STAFF RECOMMENDATION

1415 A Russell Street

May 20, 2020

Application: New Construction—Addition; Partial Demolition

SITE PLAN

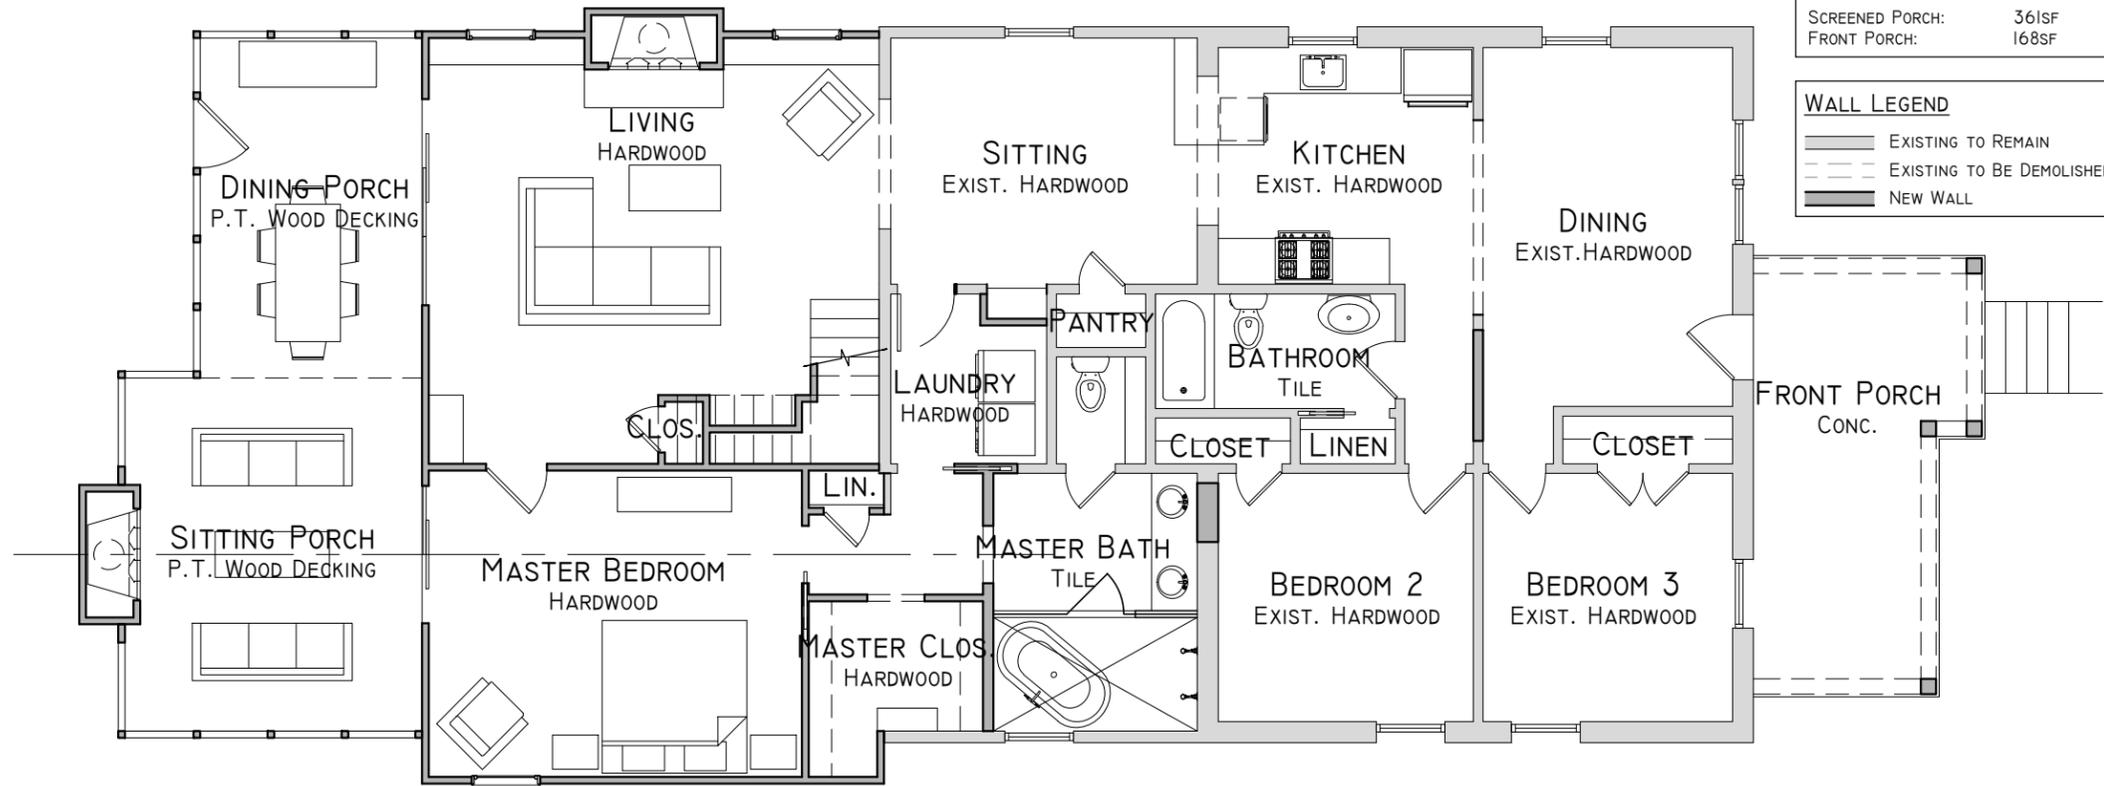
Setback & Rhythm of Spacing: The addition will meet all base zoning setbacks. It will be approximately eleven feet (11') from the left property line, seven feet (7') from the right side property line, and forty feet (40') from the rear property line. The front porch's depth will increase from six feet to ten feet (6'-10'), encroaching four feet (4') into the front setback. Staff finds that this new front setback is appropriate, as the two houses adjacent to 1415 A Russell Street have front setbacks much closer to the street and the porch will help bring 1415 A Russell closer to the street.

Staff finds that the addition's setback and rhythm of spacing to meet Section II.B.3. and II.B.10. of the design guidelines.

ELEVATIONS

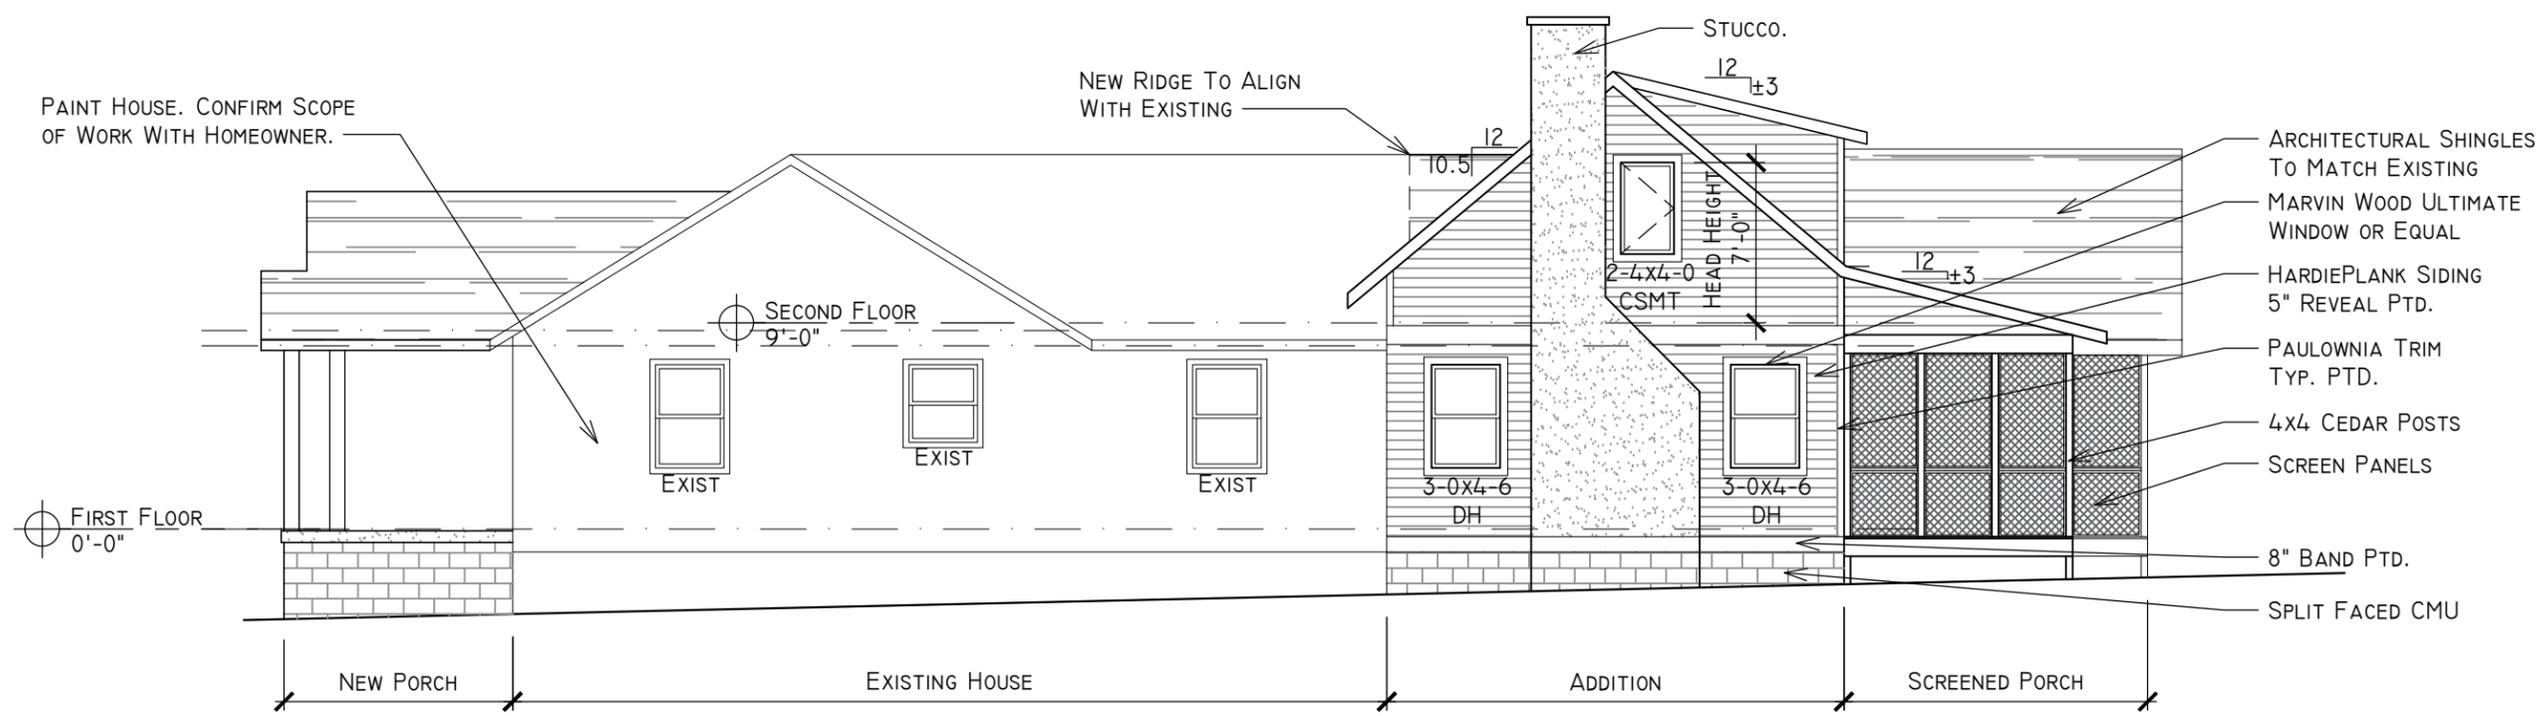
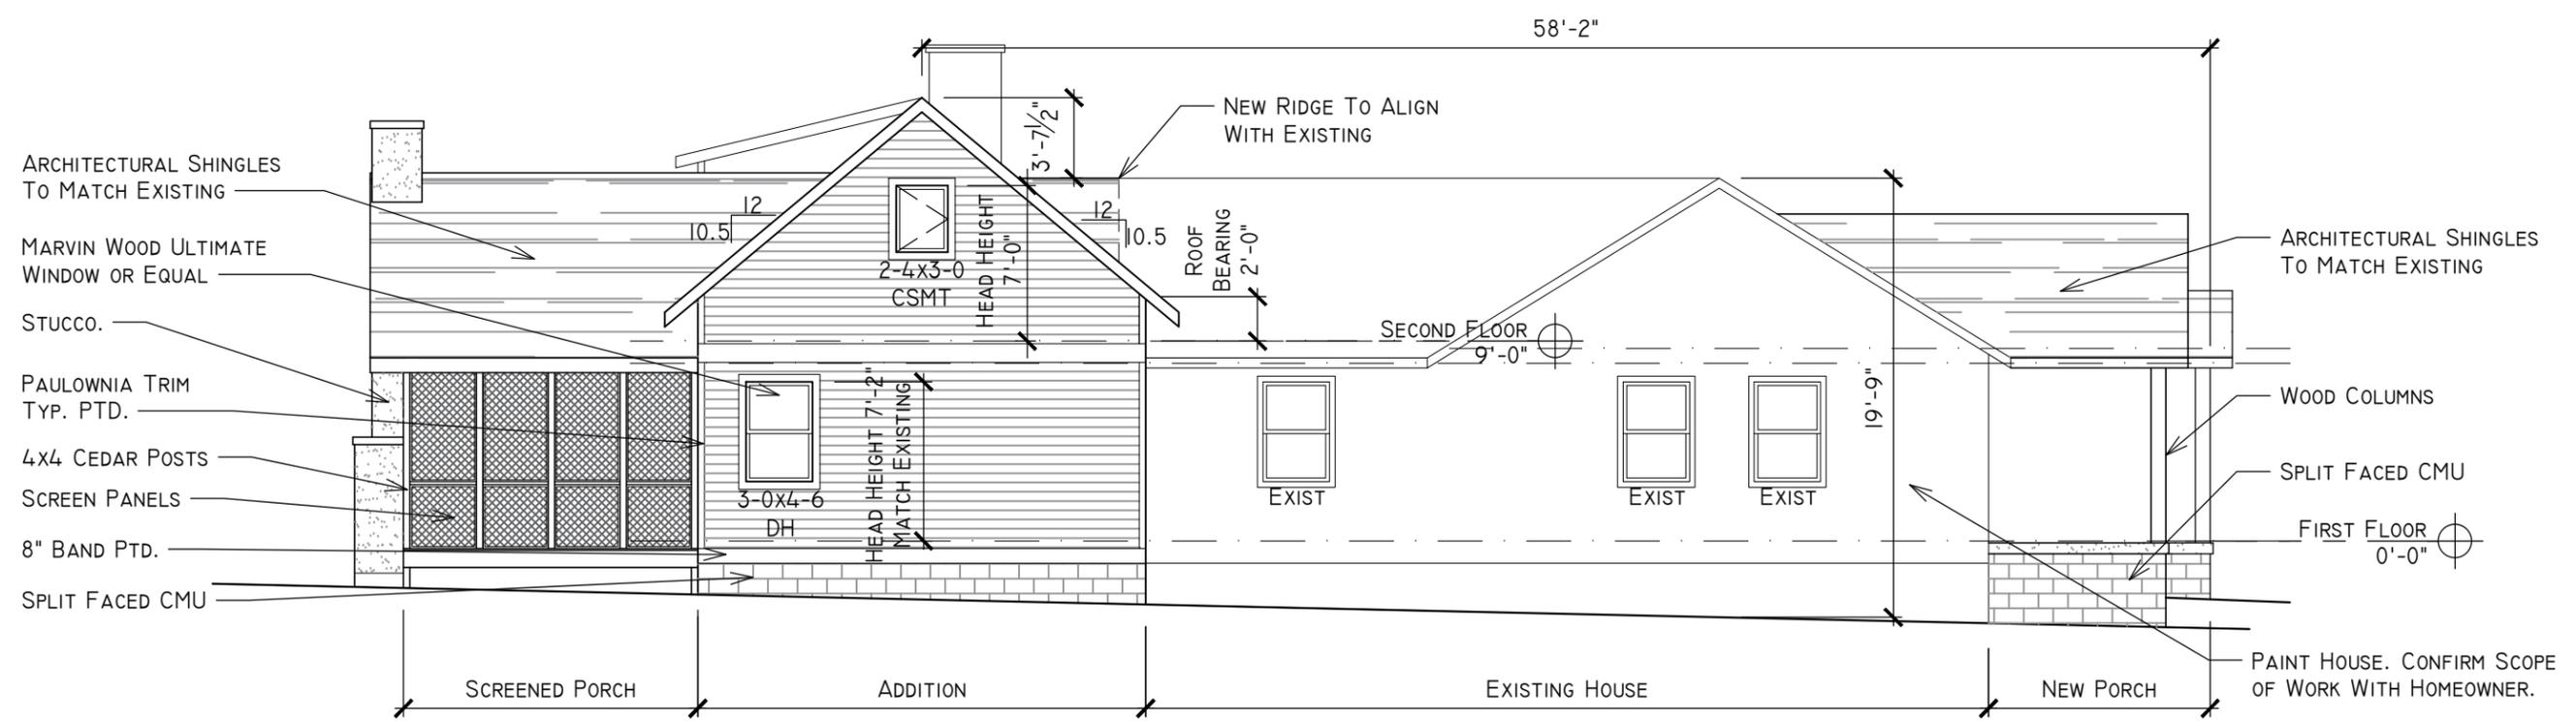
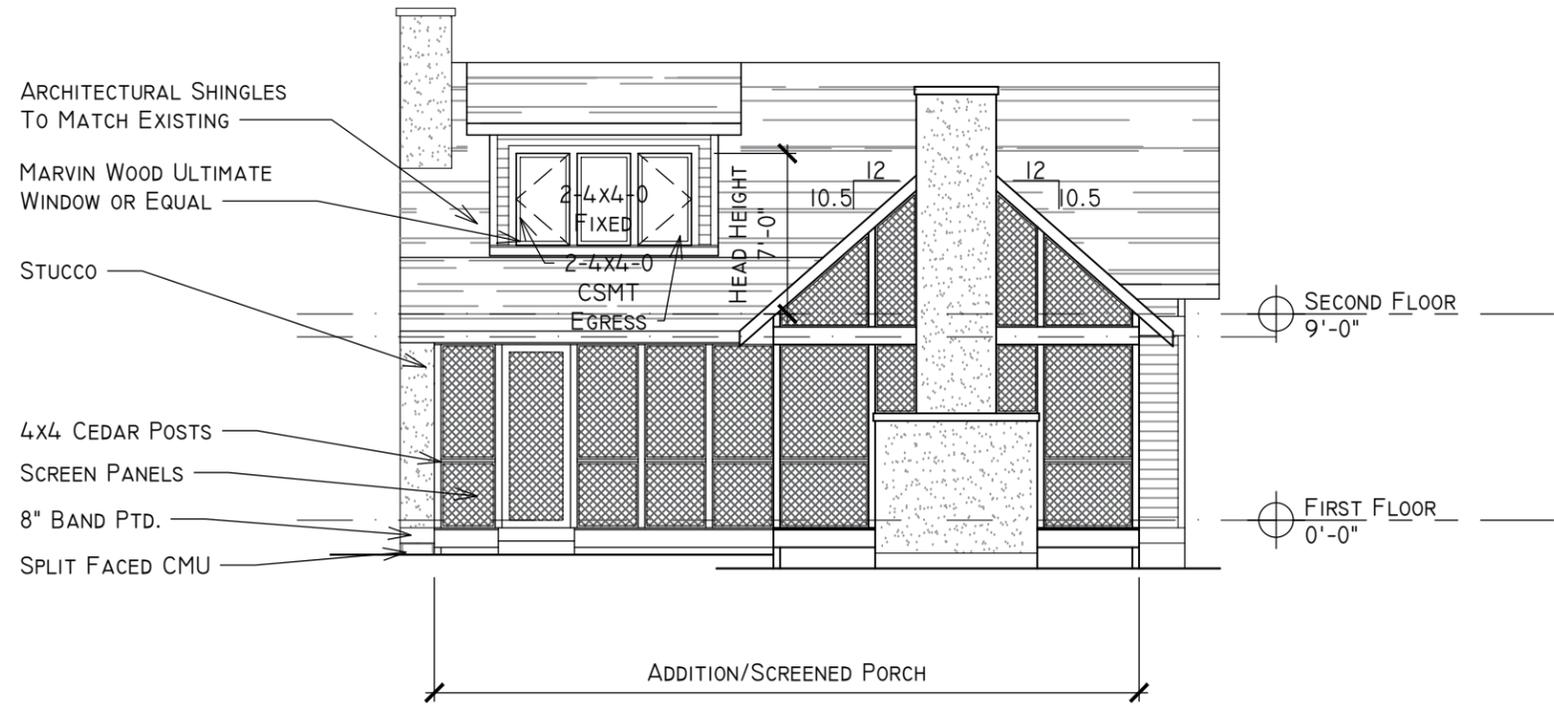
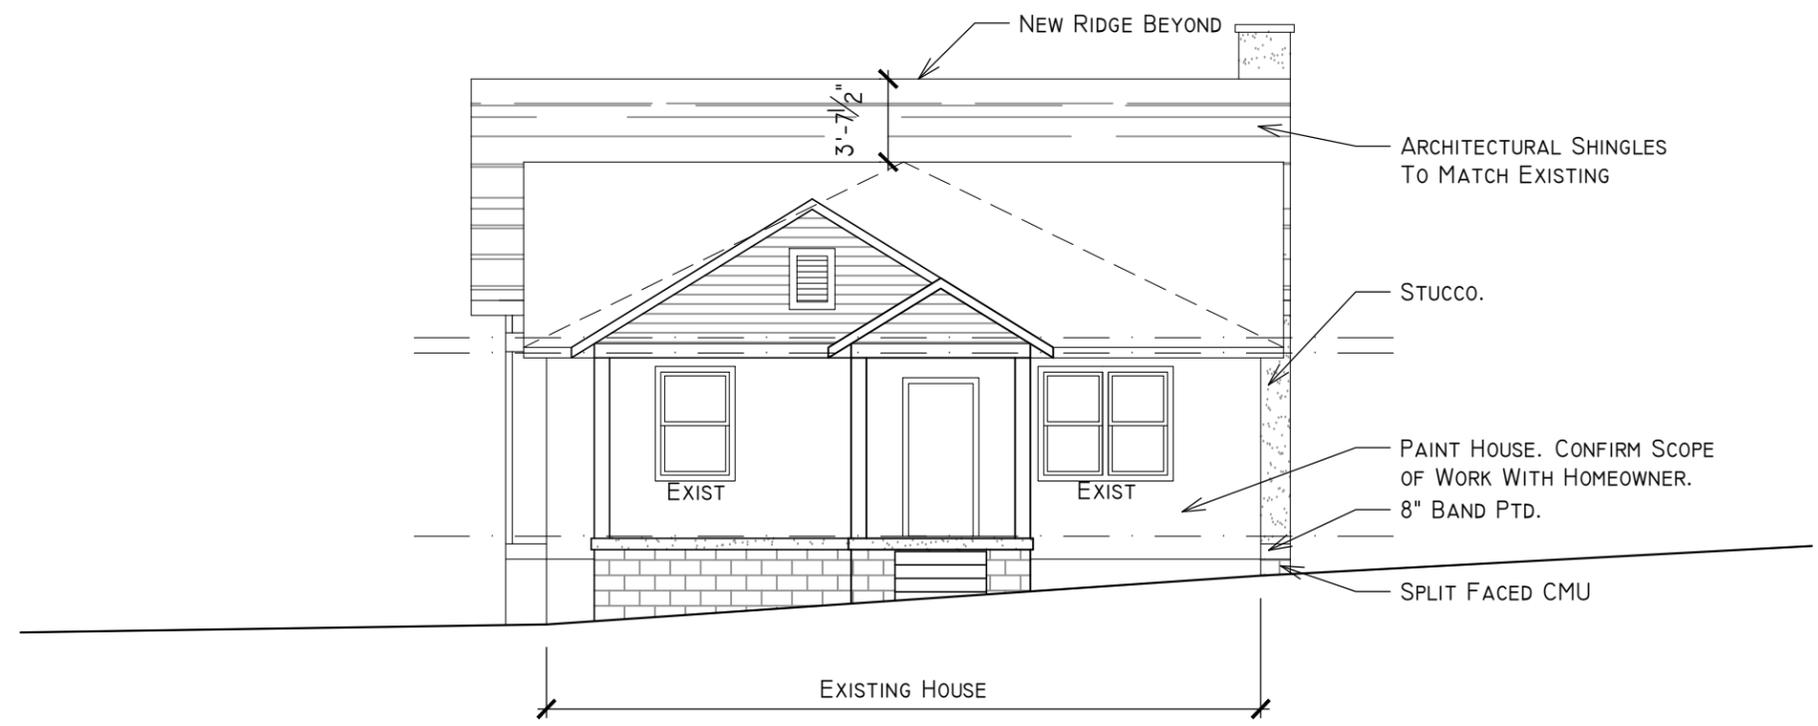
Height & Scale: The proposed rear addition will be one-and-a-half stories. It will be three feet, eight inches (3'8") taller than the existing house and is two feet (2') wider. Because the structure is non-contributing, the height and width of the addition are appropriate, as the height and width meet the larger historic context. The addition's maximum height, from grade, is approximately twenty-two feet, six inches (22'6"); its width is approximately thirty-three feet (33'). This height and width match the historic context, where historic houses are one and on-and-a-half stories in height, with heights ranging from twenty to twenty-six feet (20'-26'), and with widths ranging from twenty-eight to thirty-five feet (28'-35'). The rear addition will add one thousand and eighteen square feet (1,018 sq. ft.) of footprint to the structure. Once completed, the house will have an overall footprint of two thousand, three hundred and eighty-one square feet (2,381 sq. ft.), including the front and rear porches.

Roof form: The addition’s main roof form is a side gable with a 10.5/12 slope. The rear porch will also have a 10.5/12 gable. The rear façade will have a shed dormer with a 3/12 slope. Staff finds that these roof forms are compatible with the neighboring historic context.

Proportion and Rhythm of Openings: No changes to the window and door openings on the existing house were indicated on the plans. The windows on the proposed addition are all generally twice as tall as they are wide, thereby meeting the historic proportions of openings. There are no large expanses of wall space without a window or door opening.

Staff finds the project’s proportion and rhythm of openings to meet Sections II.B.7. and II.B.10. of the design guidelines.
